**SITE DEVELOPMENT OF THE 65-HECTARE RELOCATION SITE
IN NEW CLARK CITY (NCC)**

BID BULLETIN NO. 01

This Bid Bulletin contains clarifications raised during the Pre-Bid Conference held on 08 March 2024, as well as queries sent by prospective bidders via email, and other matters relating to the Project.

Items for Manholes for diameters 1050mm, 1200mm, & 1500mm

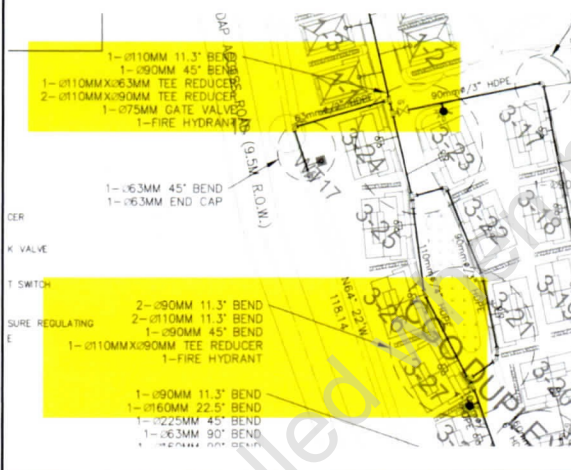
Should these be Pipe Culverts, and not Manholes, since there are Pipe culverts with diameters of 1050mm, 1200mm, & 1500mm in the drawings?

<p>604(3) • Fencing (Posts incl. footings)</p> <p>Bill of Quantities PART H - Item 604(4) • Fencing (Gates)</p> <p>Bill of Quantities PART H - Item 604(8) • Watch Tower (Perimeter Guard Post)</p> <p>Bill of Quantities PART H • Gate (Primary & Secondary Gate)</p>	
<p>Q39. <u>Bill of Quantities.</u> Part J - Item 807 (6)d; Part J - Item 607 (6)e</p> <p>Please provide the details or material finish for the Hardscape Areas and Hardscape Ponds.</p>	<p>Please see attached ANNEX D - Hardscape Areas and Ponds.</p>
<p>Q40. <u>Bill of Quantities</u> Part G - item 513 (1)</p> <p>Please provide the drawings/detail of Permanent Ground Anchor (Soil Nail)</p>	<p>Please see attached ANNEX E - Permanent Ground Anchor (Soil Nail).</p>
<p>Q41. <u>Pipe Culverts / Manholes</u> Please confirm if the following highlighted items are Pipe Culverts and not Manholes.</p> <ul style="list-style-type: none"> • item 500(1)a4 • item 500(1)a5 • item 500(1)a6 	<p>The items 500(1)a4, 500(1)a5, and 500(1)a6 should be Pipe Culvert not Manholes.</p>
